PLANNING BOARD STAFF REPORT

Re: Colonial Ridge Planned Unit Development Amendments # 3

Date: July 12, 2016

PART 4-

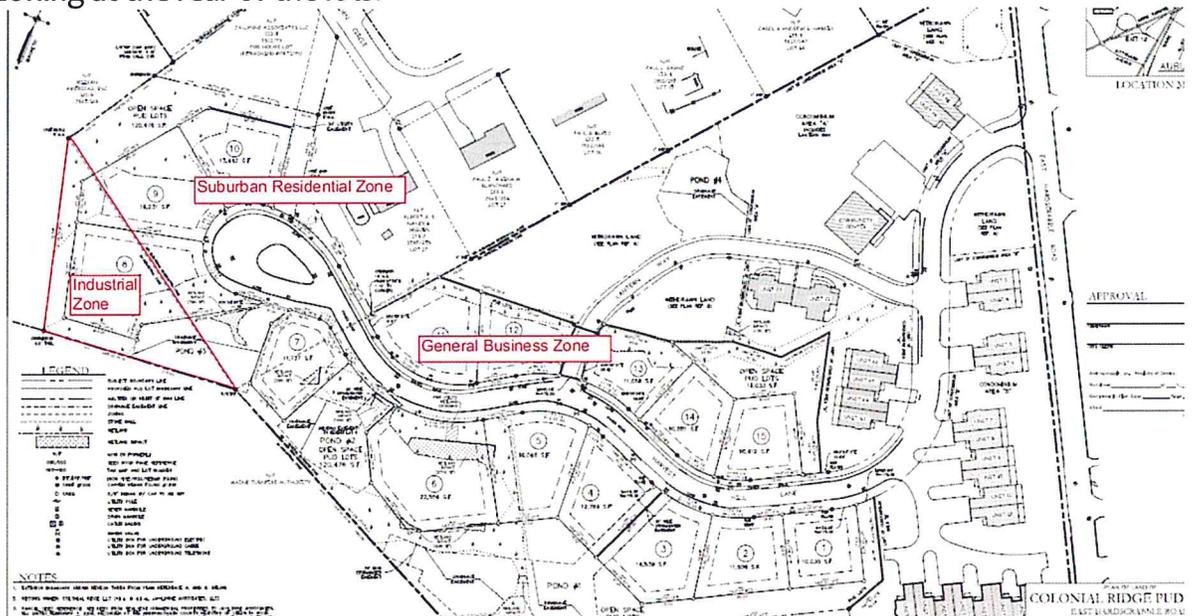
As mentioned in Section II Staff Comments, the Planning Staff was concerned with the proposed lots 8 and 9, which, according to our latest zoning map has Industrial Zoning at the rear of the lots.

This is concerning to Staff as Industrial zoning would prohibit any residential type uses. The Staff is asking the Planning Board to evaluate this situation using **Sec. 60-6-Zone Boundaries** from the Zoning Ordinance. It states:

The Staff recommends the Planning Board use parts (2) and (7) to justify changing the triangular shaped area of lots 8 and 9 from Industrial to Suburban Residential.

IV. STAFF RECOMMENDATION- The Staff recommends **APPROVAL** of Colonial Ridge PUD Amendment # 3, including the reduction of front yard setback to 15 feet for lots 1-15 and the modification of the zoning boundary for the triangular shaped area of lots 8 and 9 from Industrial to Suburban Residential Zone as per **Sec. 60-6- Zone Boundaries, parts 2 and 7**. The recommendation is made with the following findings:
